Access Compliance Report Public Rights-of-Way (Curb Ramps)

Intersection ID: 8746 Main Street: GENERAL_COMMERCE_DR Cross Street: INDUSTRIAL_CENTER_CR Location: N

ADA ID: 3C7C04B9FDCE Ramp Type: Perp Initial Pass/Fail: Fail Overall Compliance: No Severity Score: 12.5

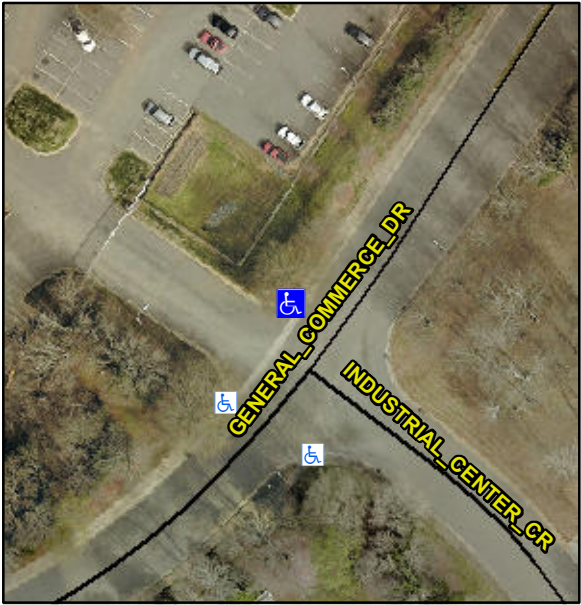
PROW/ADA:
Not Found, R304.2.2

Compliance	Description	Data	Compliance	Description	Data
N/A	Ramp Length (in)	58.0	No	Ramp Slope (%)	8.5
Yes	Ramp Width (in)	48.0	Yes	Ramp XSlope (%)	0.3
N/A	Flare Type LT	N/A	N/A	Flare Type RT	N/A
N/A	Flare Slope LT (%)	N/A	N/A	Flare Slope RT (%)	N/A
N/A	Flare Traversable LT?	N/A	N/A	Flare Traversable RT?	N/A
N/A	Landing Length (in)	N/A	N/A	DWS Provided?	N/A
N/A	Landing Width (in)	N/A	N/A	DWS Contrast?	N/A
N/A	Landing Slope (%)	N/A	N/A	DWS Length (in)	N/A
N/A	Landing X Slope (%)	N/A	N/A	DWS Full Width?	N/A
N/A	Landing Curb? (Y/N)	N/A	N/A	DWS Offset (in)	N/A
N/A	Shared Landing?	N/A			
N/A	Gutter Ponding?	Yes	N/A	Gutter Slope (%)	N/A
N/A	Gutter Lip Ht (in)	N/A	N/A	Gutter X Slope (%)	N/A
N/A	Painted X Walk1?	No	N/A	Painted X Walk2?	N/A
	X Walk 1 Direction	To SW		X Walk 2 Direction	N/A
N/A	X Walk 1 Width (in)	N/A	N/A	X Walk 2 Width (in)	N/A
	X Walk 1 Slope (%)	0.1		X Walk 2 Slope (%)	N/A
	X Walk 1 X Slope (%)	8.1		X Walk 2 X Slope (%)	N/A

Possible Solutions:
Remove & Replace Entire Ramp.
